Assessment of the 2008 North Florida Numerical Groundwater Flow Model

Limitations & Implications for Groundwater Resource Management

January 21, 2014

Prepared for:

Figure 10 – NFM-08 Calibration Residuals

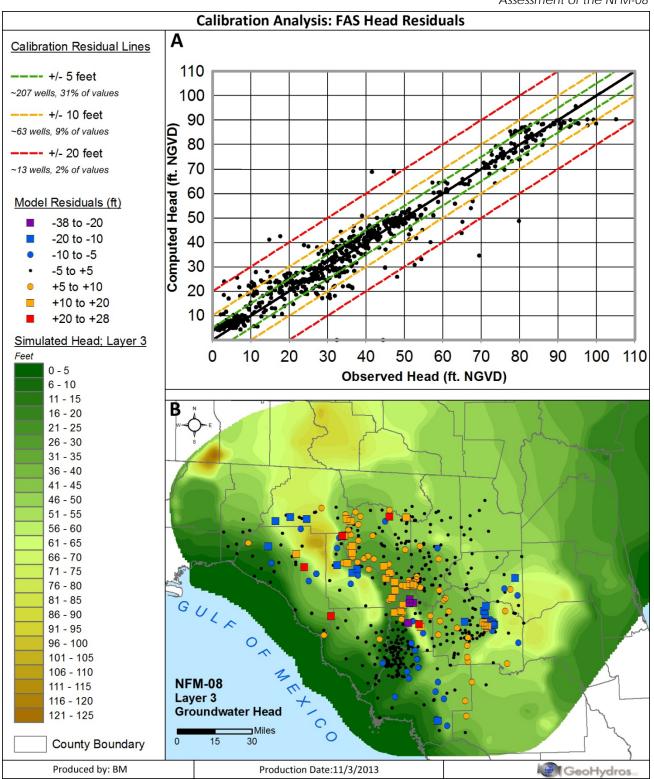
Figure 10 shows how the SDII model calibrated to the observed groundwater elevations (heads). The average error (residual) between simulated and observed groundwater levels was 4.3 feet and because that value is less than the 5-foot target, SDII considered the model to be acceptably calibrated. The plot shown in Figure 10A was reproduced from the SDII report. It shows however that the error at many of the wells is considerably larger than the 5-foot criterion. The calibration dataset was not made available for this review but an estimate from the plot provided in the SDII report revealed that the error at 13 of the wells (~2% of values) is larger than 20 feet, the error at approximately 63 of the wells (~9% of values) is larger than 10 feet, and the error at approximately 207 of the wells (~31% of values) is larger than the 5-foot calibration criterion.

- differences between observed and simulated groundwater levels of between -36 to +28 feet (Figure 10);
- differences between the observed depth of the cone-of-depression associated with groundwater pumping by the city of Gainesville and the simulated value of more than 30 feet (Figure 12 and Figure 13);

Calibration residuals mark the difference between UFA groundwater elevations measured between 6/1/01 and 5/31/02 and values simulated by the NFM-08. The plot (A) is reproduced from the SDII report, which compares modeled values to measurements from 676 wells throughout the domain. Points that fall exactly along the black line represent a perfect match between simulated and measured values. The dashed lines bracket progressively larger discrepancies. Statistics revealing that the calibration criterion was violated at more than 30% of the wells are shown at the top left. The map (B) shows the distribution of residuals determined from 534 wells monitored by the SRWMD and the ACEPD. In that dataset, residuals were larger than 5 feet at 147 wells (28%), larger than 10 feet at 54 wells (10%), and larger than 20 feet at 12 wells (2%). The model under-predicts groundwater elevations in the high regions and over-predicts in the low regions.

Figure 11 – NFM-08 – River and Drain Cell Deviations from Target River Stage

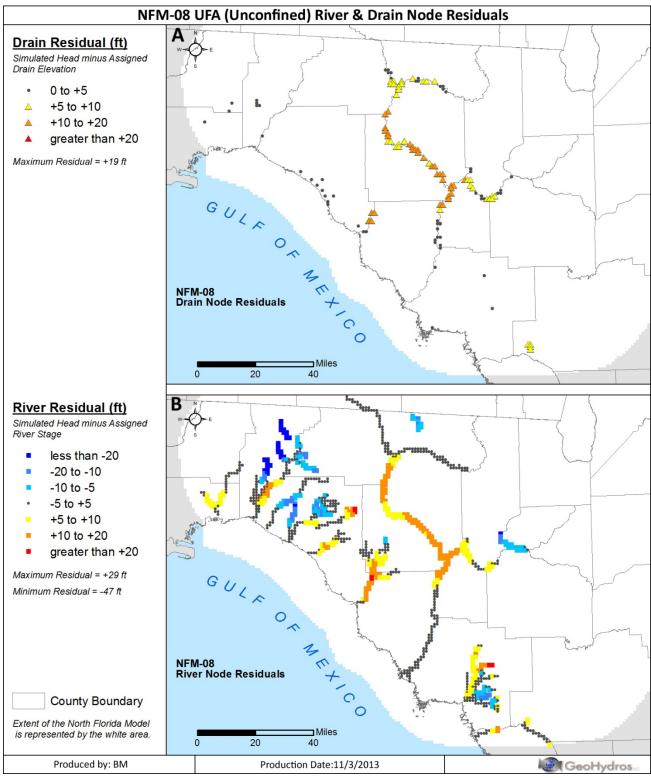
Figure 11 shows that the deviations occur at a significant portion of the assignments representing river reaches that receive groundwater discharge from the UFA. The largest deviations occur in the central Suwannee, Santa Fe, Steinhatchee, and Aucilla Rivers. The model simulated groundwater levels throughout a significant portion of the central Suwannee and Santa Fe Rivers is higher than the observed river stage by more than 5 feet. The reaches surrounding the confluence with the Santa Fe River and below the confluence with the Withlacoochee River is elevated by between 10 and 20 feet. Deviations in some of the coastal rivers rise to more than 20 feet. These discrepancies occurred because PEST was allowed to adjust the streambed conductance term as needed to match the flows. If the model simulated too much flow, PEST reduced the streambed conductance, which allowed less flow out of the cell while

rivers where the model typically overestimated stage by feet to tens of feet (Figure 11). Both the variation in streambed conductance and the unreasonable simulation of groundwater levels at the rivers substantially undermine the significance of the near-perfect match between simulated and observed spring and river flows yet neither of these conditions were discussed in the report.

The distribution of all drain (top) and river (bottom) assignments applied to model cells in layer-3 (the UFA layer) in the calibrated version of the NFM-08 and the degree to which the simulated groundwater elevation at the river deviated from the observed river stage. Colors denote errors of 5, 10, and 20 feet. The model contained 831 discharging River assignments and 147 discharging Drain assignments. The model over-estimated the groundwater levels at the rivers by more than 5 feet at 471 (48%) of these cells, by more than 10 feet at 231 (24%) of these cells, and by more than 15 feet at 80 (8%) of these cells. Adding these deviations to the residuals computed for the 534 average groundwater elevations recorded in the SRWMD during the model calibration period raises the average absolute residual to 5.6 feet, which causes the model to fail SDII's test for calibration.

Figure 12 – NFM-08 – Comparison of Simulated & Measured Groundwater Surfaces – Gainesville Well Field

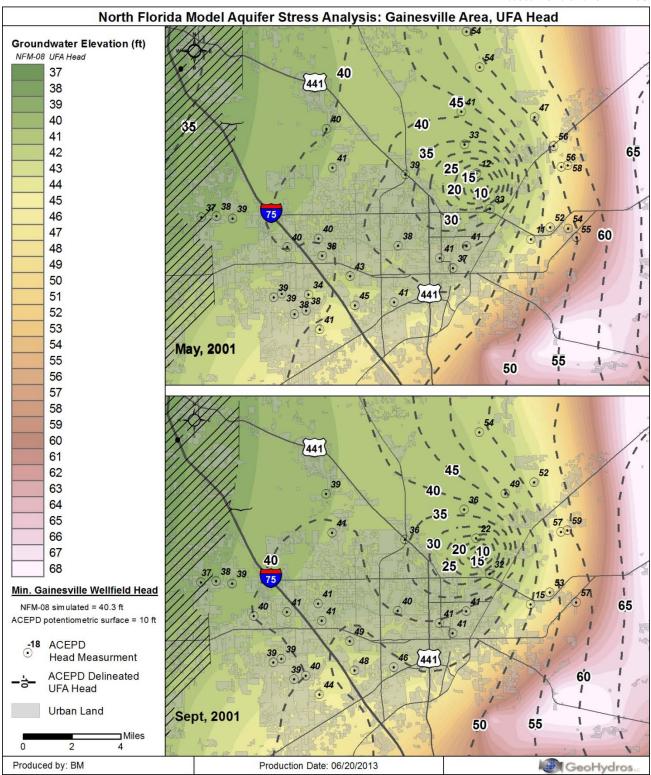
Figure 12 and Figure 13 compare the model-simulated groundwater surface to the May 2001 and September 2001 surfaces measured by the ACEPD. [59] The comparison shows that the NFM-08 overpredicts the groundwater surface, which means it under-predicts the impact of the pumping by as much as 30 feet in the vicinity of the Gainesville well field even though the model simulated the appropriate pumping rate of 25 MGD for the collective City wells. The magnitude of the error is highest in the center of the mapped cone-of-depression and extends for approximately 2 miles in all directions from that point.

Both figures show the model-simulated groundwater surface (potentiometric surface) for the period between June 1, 2001 and May 31, 2002 as a color-flood. The dashed lines show the groundwater surface for the same region as mapped and published by the Alachua County Environmental Protection Department for May 2001 (top) and September 2001 (bottom). The two surfaces strongly disagree in the vicinity of the City of Gainesville well field where pumping has caused a deep and broad cone of depression. The lowest elevation in the simulated groundwater surface is 40.3 feet, which occurs near the centroid of the three Gainesville municipal water supply wells. The measured elevation at that point was approximately 10 feet during both of the measurement periods.

Figure 13 – NFM-08 – Difference between Simulated & Measured Groundwater Surfaces – Gainesville Well Field

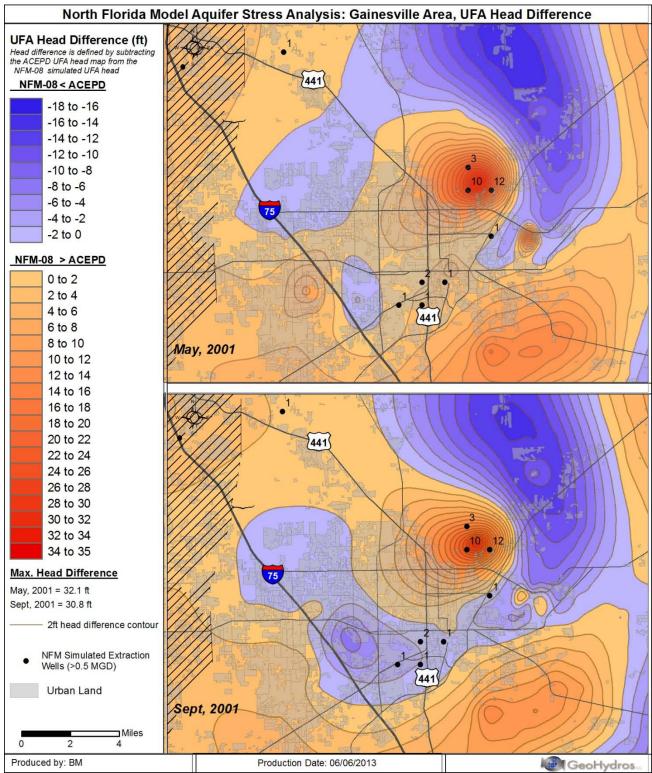
Both figures show the difference between the simulated and measured groundwater surfaces in the vicinity of the City of Gainesville municipal well field (simulated minus measured) as color floods. Red and orange colors mark regions where the simulated surface is higher than the measured surface. Blue colors mark regions where the simulated surface is lower than the measured surfaces are from pontentiometric surfaces drafted by the Alachua County Environmental Protection Department (ACEPD) for May 2001 (top) and September 2001 (bottom). The maximum differences between the simulated and observed depth of the cone-of-depression in the groundwater surface created by Gainesville's pumping were 32.1 and 30.8 feet respectively revealing that the model dramatically under-predicts the impact of the pumping on aquifer water levels and groundwater flow paths.

Figure 14 – NFM-08 – Simulated Capture Zone for the City of Gainesville Well Field

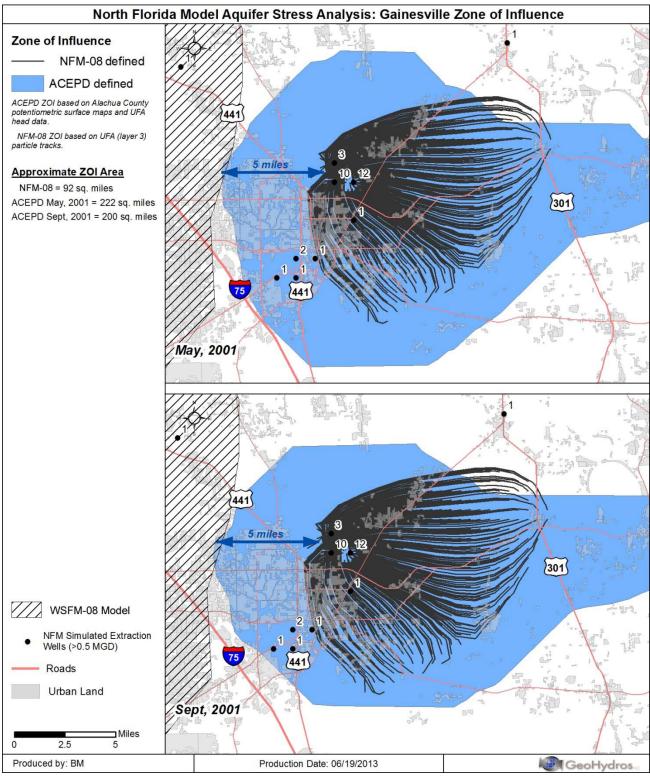
Figure 14 compares the model-simulated capture zone for the Gainesville well field as defined by particle tracking to the capture zones defined from potentiomentric surface maps developed by the ACEPD from groundwater elevations measured during May and September 2001. [59] The model substantially underestimates the size of the capture zone for the well field. This significantly affects the model's ability to predict impacts to the Santa Fe River because the model underestimates the western extent of the measured and thus confirmed zone of influence by as much as 5 miles. That equates to nearly 50 square miles of recharge that the model indicates will flow to the springs along the Santa Fe River, which in fact flows instead to the well field. More broadly, it therefore under-estimates the extent to which any investments in return flow (artificial recharge, aquifer storage and recovery, etc) will result in a benefit to the City and the river.

The black lines in both the upper and lower figures are particle tracks marking the groundwater flow paths to the City of Gainesville's water supply wells as simulated by the NFM-08. The simulated well extraction rates are shown as black dots and labeled by the simulated magnitude of extraction in MGD. The underlying blue regions are the capture zones delineated from the May 2001 (top) and September 2001 (bottom) potentiometric surface maps produced by the Alachua County Environmental Protection Department (ACEPD) from measured groundwater elevations, which denote measured real-world conditions during the model calibration period. In both cases, the simulated capture zone is substantially smaller than the measured extent and, most importantly, does not extend as far to the west where depressed groundwater elevations more greatly impact groundwater flow to the western Santa Fe River.

Figure 15 – NFM-08 – Comparison of Simulated & Measured Groundwater Surfaces – Fernandina Beach

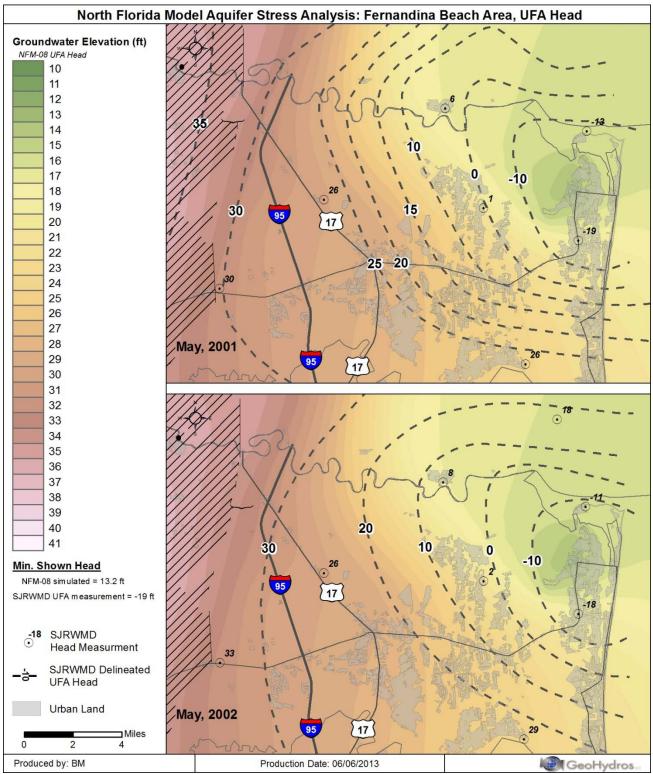
Figure 15 and Figure 16 compare the model-simulated groundwater surface to the May 2001 and May 2002 groundwater surfaces measured by the SJRWMD in the vicinity of Fernandina Beach, where the UFA groundwater surface is known to be impacted by pumping. [65,66] These maps reveal that the model's inability to reasonably simulate the response of the UFA to stress due to pumping is not limited to the Gainesville area. In the Fernandina area, the model under-predicts the impact of pumping by approximately 35 feet. The impacts of unreasonably simulating the cone-of-depression occur both locally and regionally. Local impacts are demonstrated by the magnitude of the difference between the simulated and measured depth of the cone-of-depression. Regional impacts are manifest by the difference in the size and location of the simulated capture zone. In the case of the Fernandina area, those regional differences affect the location of simulated groundwater divides that, in turn, affect model-simulated flow to the upper Suwannee River basin.

Both figures show the model-simulated groundwater surface (potentiometric surface) for the period between June 1, 2001 and May 31, 2002 as a color-flood. The dashed lines show the groundwater surface for the same region as mapped and published by the St. Johns River Water Management District (SJRWMD) for May 2001 (top) and May 2002 (bottom). The two surfaces strongly disagree in the vicinity of the pumping center, which has caused a deep and broad cone of depression. The lowest simulated elevation is 13.2 feet, which occurs near the center of cone-of-depression whereas the measured elevation at that point ranged from -18 to -19 feet during both measurement periods. By not reasonably simulating the depth or extent of the cone-of-depression, the model not only under-predicts the local impacts of pumping but also under-predicts regional impacts on groundwater flow directions such as flow to the upper Suwannee River basin.

Figure 17 – NFM-08 – Comparison of Model Residuals to Observed Range in Groundwater Surface

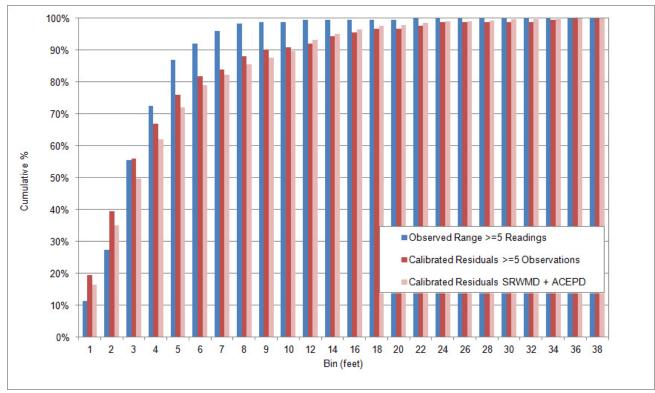
Table 5 compares histogram values for the observed range in groundwater elevations at the 175 wells with five or more measurements during the calibration period to the associated absolute residuals produced by the model for the 175-well subset and the full 534-well record. The statistics show that water levels varied by more than 9 feet in only about 1% of the subset wells whereas approximately 12% - 13% of the model residuals exceeded that value again indicating that the 5-foot calibration criterion was too broad. Figure 17 shows the bin values and cumulative percentages graphically.

The blue bars show the cumulative distribution of groundwater surface variations measured in 175 of the 475 wells maintained by the SRWMD that were used for model calibration and had more than five measurements during the June 1, 2001 to May 31, 2002 calibration period. The groundwater surface varied by less than 3 feet in 56% of those wells and by less than 4 feet in 73% of the wells. By comparison, the distribution of model residuals was skewed toward higher values indicating that the 5-foot criterion for calibration was too permissive to insure that the final model realistically simulated the observed range in groundwater surface elevations.

Figure 18 – NFM-08 – Comparison of Simulated Flow Paths to Traced Connections

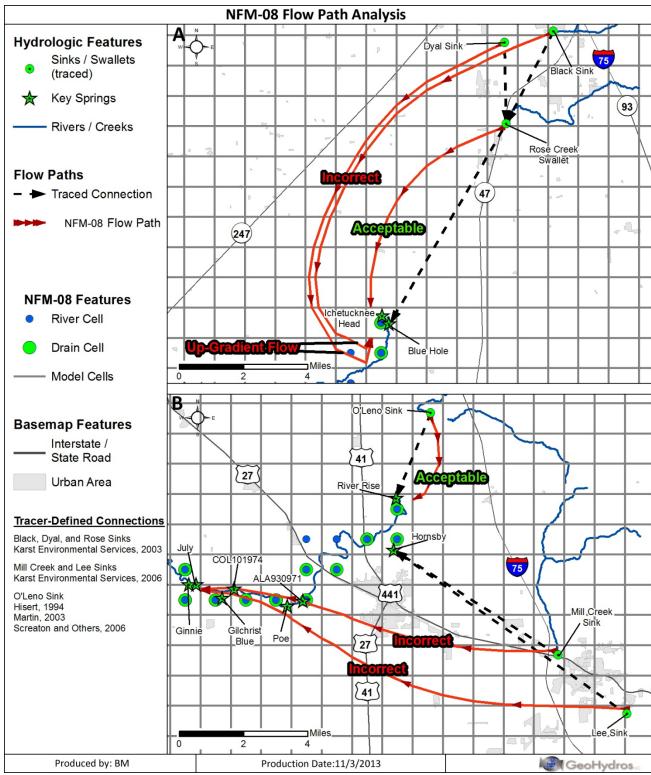
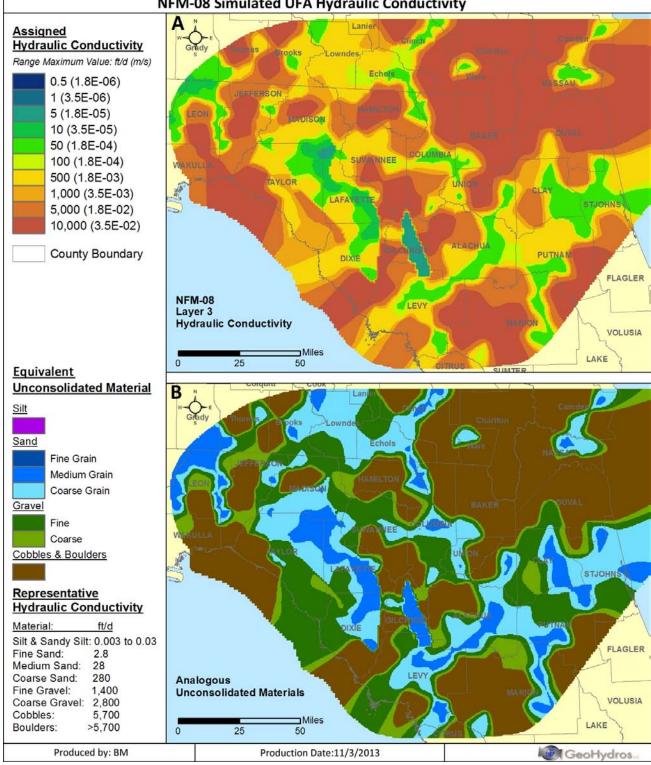
Figure 18 compares flow paths simulated by the NFM-08 to connections established by groundwater tracing. A reasonable expectation for a model intended to predict impacts to specific springs, rivers, and wells would be a reasonable approximation (or calibration to) known connections between different locations in the aquifer. Six such known connections, as well as the groundwater flow velocities between the connected locations, had been established prior to the development of the NFM-08.

Figure 18 (top) shows tracer-defined connections between three sources of direct recharge to the UFA (Black Sink, Dyal Sink, and Rose Creek swallets) and select springs discharging to the Ichetucknee River. [55] The tests revealed that flow from the three sinks traveled specifically to Blue Hole, Mission, and Devil's Eye Springs and not to Ichetucknee Head, Cedar Head, Mill Pond or Grassy Hole Springs. [55] The NFM-08 cannot discriminate different flow paths and thus different springsheds for Ichetucknee Head, Cedar Head, Blue Hole, and Mission Springs because all of those springs were assigned to the same model cell. Similarly, the model grouped Devil's Eye, Grassy Hole, and Mill Pond Springs into a single cell located immediately south (downstream) of the cell containing the head springs. The model correctly simulated the flow path from the Rose Creek swallet to Blue Hole but, because of the spring groupings, failed to show that Blue Hole and Inchetucknee Head Springs derive water from distinctly separate sources. The model incorrectly simulates flow paths between Dyal and Black Sinks and the springs because it fails to show that the water travels through Rose Creek Swallet before discharging at the springs and it shows that part of the flow reaching Devil's Eye, Grassy Hole, and Mill Pond Springs travels upstream to Ichetucknee Head, Cedar Head, Blue Hole, and Mission Springs.

Figure 18 (bottom) shows tracer-defined connections between three sources of direct recharge to the UFA (Lee Sink, Mill Creek Sink, and O'leno Sink swallets) and the River Rise and Hornsby Spring at the upper end of the western Santa Fe River. The connection between O'leno Sink and the River Rise has been well established since 1991 through artificial and natural tracer tests. [54,56,57] The connections between Lee Sink and Mill Creek swallets and Hornsby Spring were established in 2006 through dye tracing. [58] Those traces revealed a strong connection to Hornsby Spring, a weaker connection to Darby Spring, located immediately downstream of the Hornsby Spring run and east of Highway 441, and no connection to the downriver springs.

- substantial discrepancies between observed and simulated groundwater flow paths (Figure 18);
- substantial discrepancies between the modeled hydraulic conductivity values and the magnitude of values established by data (Figure 22) as well as divergence from the distribution of values reflected by established hydrogeologic zonation in the UFA (Figure 23);

Figure 20 – NFM-08 – Comparison of Equivalent Transmissivity Values to Values Derived from Data Published in 2012

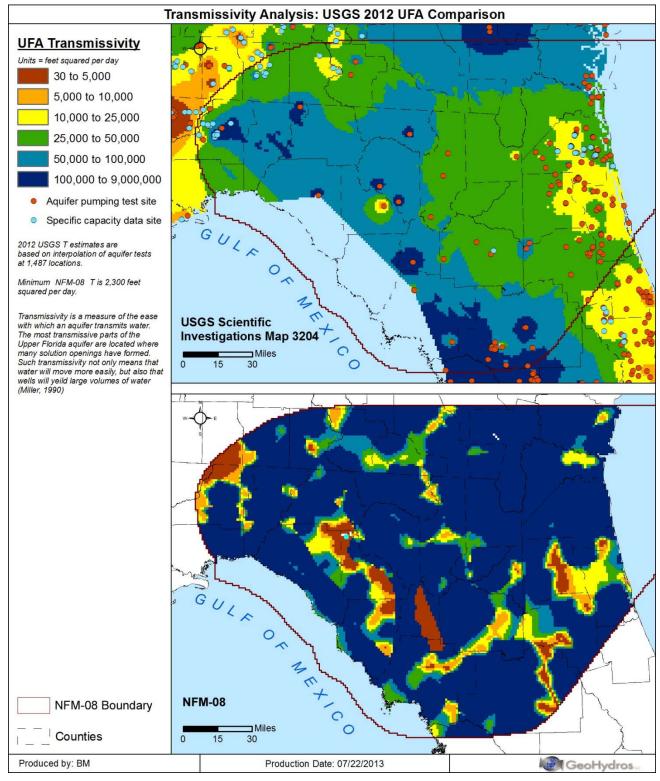
Significant deviations in both the magnitude and distribution of hydraulic conductivities exist when comparing the NFM-08 values to reported values (in the form of transmissivity) based on aquifer test data (Figure 20 and Figure 21) that were published by the USGS in 1990 [67] and 2012. [32] The 2012 USGS transmissivity map is based on an interpolation of 1,487 aquifer tests that produced a grid of transmissivity in the UFA with a range between 2,400 to 520,000 feet squared per day. [32] The 1990 USGS map is based on aquifer tests, geology, and simulation and shows a range in transmissivity for the UFA between <10,000 and >1,000,000 feet squared per day. [67] By comparison, the equivalent NFM-08 transmissivity values range from 2,300 to 9,654,000 feet squared per day.

(Top) Distribution of transmissivity in the UFA defined from aquifer test data and presented by the USGS [32] generally showing lower tansmissivity in the eastern part of the aquifer and in the Gulf Trough where the UFA is confined and higher transmissivity in the western part of the aquifer where it is unconfined. The very high points in the west are associated with tests reported to be close to known conduit systems. The very low point is associated with a test reported to be distant from a conduit zone. (Bottom) Distribution of eqivalent transmissivity in the NFM-08, which was calculated by by multiplying the assigned horizontal hydraulic conductivity and the thickness of the UFA (model layer 3) at each model cell. The SDII values were set by PEST during model calibration. They are generally 1-2 orders of magnitude higher than the USGS values and are not distributed according to known hydrogeologic zonation.

Figure 21 - NFM-08 – Comparison of Equivalent Transmissivity Values to Values Derived from Data Published in 1990

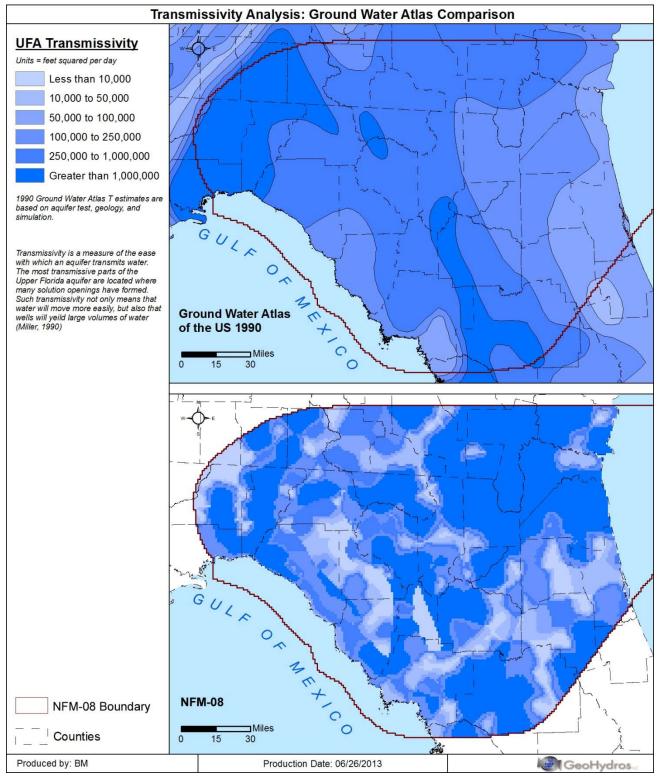
(Top) Distribution of transmissivity in the UFA defined from aquifer test data, geology, and simulation presented by the USGS [67] that generally shows lower tansmissivity in the eastern part of the aquifer where it is confined by the overlying Hawthorn Formation and higher transmissivity in the western part of the aquifer where it is unconfined with another lower transmissivity zone along the Gulf of Mexico coast. (Bottom) Distribution of eqivalent transmissivity in the NFM-08, which was calculated by by multiplying the assigned horizontal hydraulic conductivity and the thickness of the UFA (model layer 3) at each model cell and binned according to the USGS map values. The SDII values were set by PEST during model calibration. They are generally higher than the USGS values and are not distributed according to known hydrogeologic zonation.
